REV.  
B

AS3152™

BOLT, MACHINE - DOUBLE HEXAGON EXTENDED WASHER HEAD, CLOSE TOLERANCE SHANK, AMS4967 (UNS R56400), 160 KSI, .5000-20 UNJF-3A

ISSUED 1976-11 REAFFIRMED 2004-07 REVISED 2019-12

FIGURE 1 - BOLT

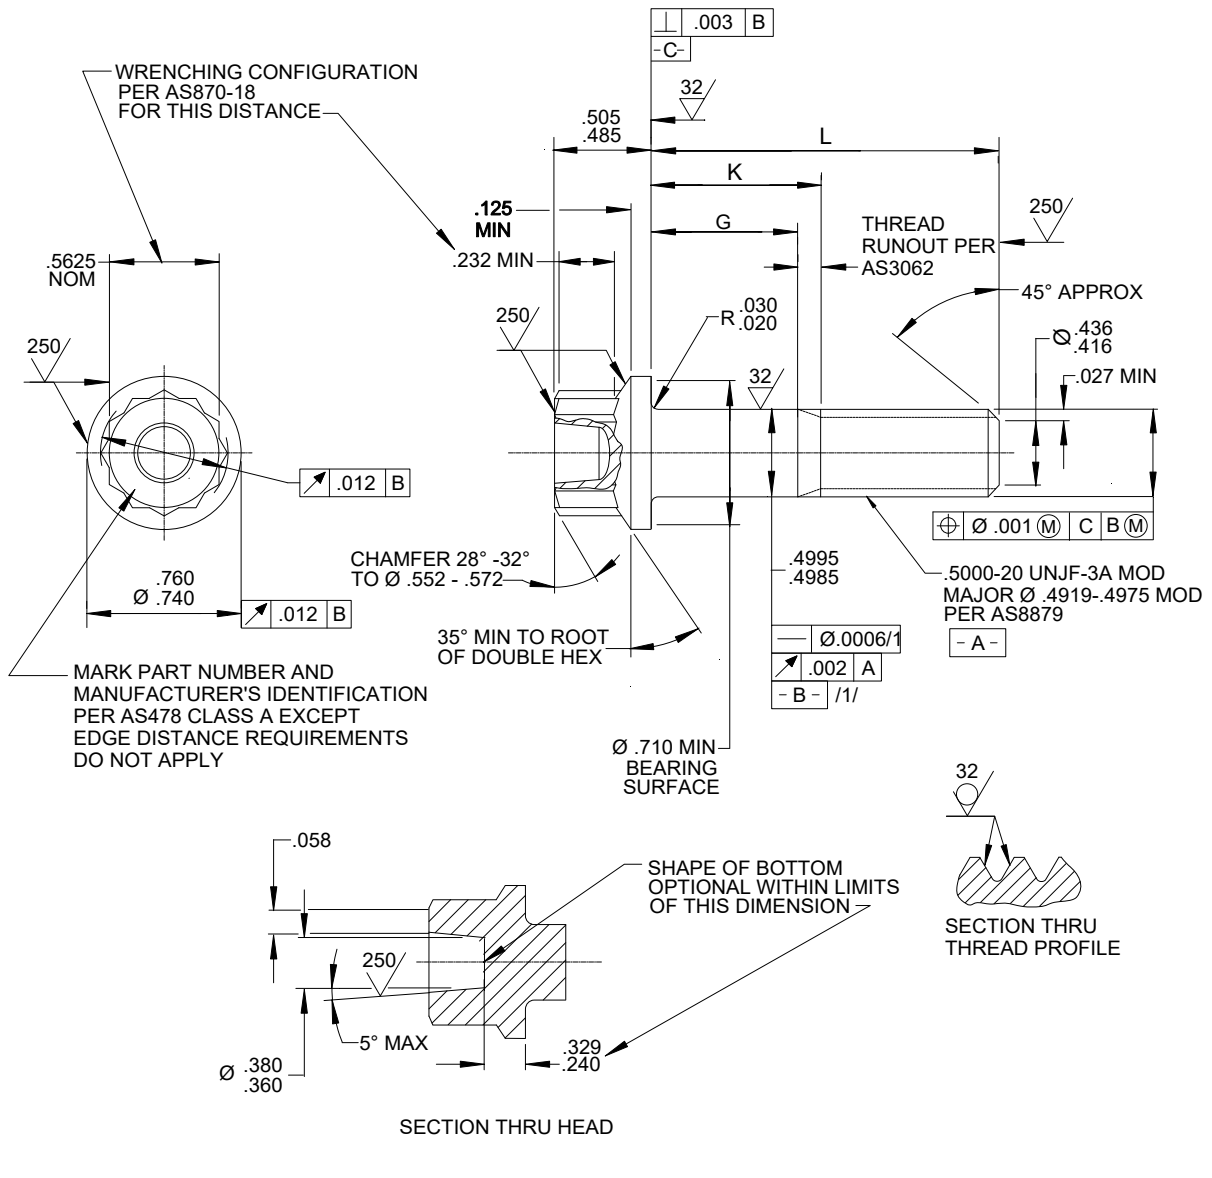
FIGURE REDRAWN TO SHOW CORRECT THREAD END CHAMFER AND LIGHTENING HOLE DIMENSIONS TO AS1132.
